MRP Application for Class-III Access Protection

Ali Sajassi

IEEE Meeting November 13, 2007

Issue with Clause 25.9.2

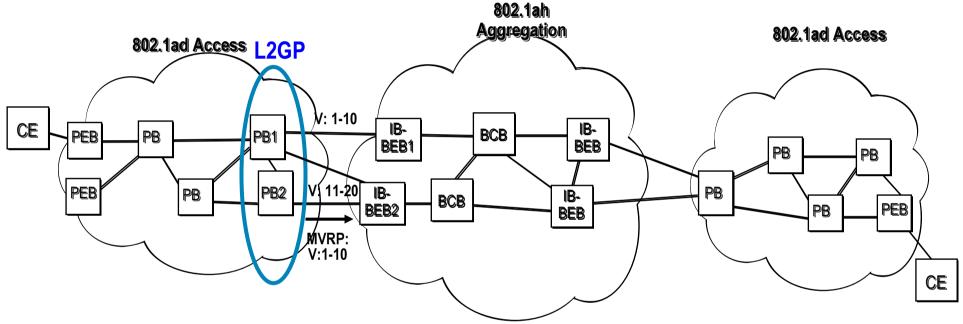
- Customer 802.1ad network runs L2GP and PB2 notifies IB-BEB2 of newly activated S-VLANs via MVRP message
- But it doesn't specify what IB-BEB2 does with this info
- IB-BEB-2 must notify other remote IB-BEBs of this change or else traffic will get black holed !!
- The best way to notify the remote IB-BEBs is via a message that contains the effected I-SIDs (and not S-VIDs)
- It also doesn't specify how class-III protection works for I-tagged service interface

Scenario-1: Redundancy between 802.1ad and 802.1ah networks using L2GP

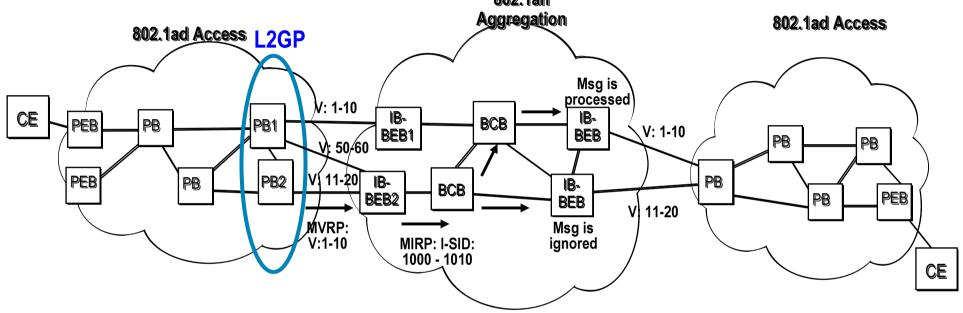
- 1. PB devices run L2GP which is based on MSTP
- 2. Upon a failure, L2GP protocol on PB1, reflects the uplink port status of PB1 onto MSTP and PB2 becomes active for V: 1-10
- 3. PB2 uses MVRP to notify IB-BEB2 of newly activated VLANs
- 4. IB-BEB2 notifies other remote IB-BEB devices using MRP-based message to flush their MACs associated w/ V: 1-10

When providing a class III protected S-tagged interface, multiple CNPs, each on a different BEB, are used to create a single S-tagged interface. Each LAN of the S-tagged interface executes PHY management, or CFM, or both at the port level to detect failures over the interface LANs. Information from PHY management and/or CFM is used by the customer to determine which LANs of the S-tagged interface are operating and which are inactive. No BPDUs from the customer network or from the Provider network are delivered over the interface LANs which form the protected S-tagged interface. The L2GP (13.37) protocol is run on the customer network which determines which S-VLANs are active on which LANs of the class III interface. Upon an active link failure between customer node and its corresponding BEB or upon the customer node failure, the customer network switches to one (or more) of the backup links and informs the PBBN which S-VLANs are active on which links using MVRP (11.2) on the access LANs. The BEB(s) upon receiving the MVRP message(s) from the customer network generate the corresponding MRPbased message(s) for the effected I-SIDs and send these messages over the associated B-VLANs. The far-end BEBs, upon receiving these messages, will flush their C-MAC entries in their filtering database corresponding to the effected I-SIDs.

Scenario-2: Redundancy between 802.1ad and 802.1ah networks over I-tagged I/F

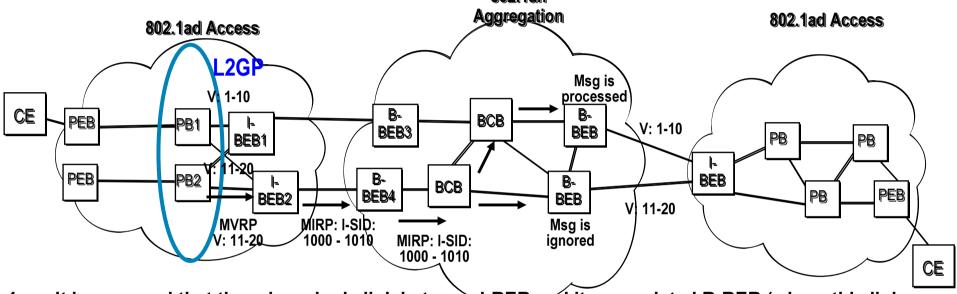
- 1. It is assumed that there is a single link between I-BEB and its associated B-BEB (where this link can be protected by class-II protection)
- 2. PB devices run L2GP which is based on MSTP
- 3. Upon an S-tagged I/F failure, L2GP protocol on PB1 reflects the uplink port status of PB1 onto MSTP and PB2 becomes active for V: 1-10 (if uplink of I-BEB fails, then all its access-facing ports are deactivated).
- 4. PB2 uses MVRP to notify I-BEB2 of newly activated VLANs
- 5. I-BEB2 in turn generates a MRP-based message listing the effected I-SIDs and send this message to B-BEB4
- 6. B-BEB4 relays this message to far-end BEBs over the corresponding B-VLANs
- 7. The far-end BEBs upon receiving MRP-based message flush their C-MAC entries associated with the effected I-SIDs

When providing a class III protected I-tagged interface, multiple Customer Backbone Ports, each on a different B-BEB, are used to create the single I-tagged interface. In this scenario, each B-BEB is connected via a single link to the customer I-BEB where the link can be class II protected. The customer I-BEB is in turn connected via multiple CNPs to the customer network. The L2GP (13.37) protocol is run on the customer network (excluding I-BEBs) which determines which S-VLANs are active on which LANs connected to CNPs of I-BEBs. In the case of an I-tagged interface, no BPDUs from the customer network or from the Provider network are delivered over the interface LANs which form the I-tagged interface. Furthermore, no customer BPDUs are exchanged over the S-tagged interface connecting the customer I-BEBs with the customer network. Each LAN of S-tagged interface executes PHY management or CFM at the port level to detect failures over the interface LANs between the customer I-BEBs and the customer network. When a failure is detected, the customer network informs the customer I-BEBs which S-VLANs are active on which links using MVRP (11.2). The customer I-BEBs in turn notify the provider B-BEBs using MRP-based messages corresponding to the effected I-SIDs. The provider B-BEBs relay this message to the other BEBs in the PBBN over the associated B-VLANs. The far-end BEBs, upon receiving these messages, will flush their C-MAC entries in their filtering database corresponding to the effected I-SIDs. Each LAN of the I-tagged interface also executes PHY management or CFM at the port level to detect failures over the I-tagged interface. In case of a complete I-tagged interface failure between the customer I-BEB and the provider B-BEB, the I-BEB uses this info to de-activate all its CNP ports toward the customer network
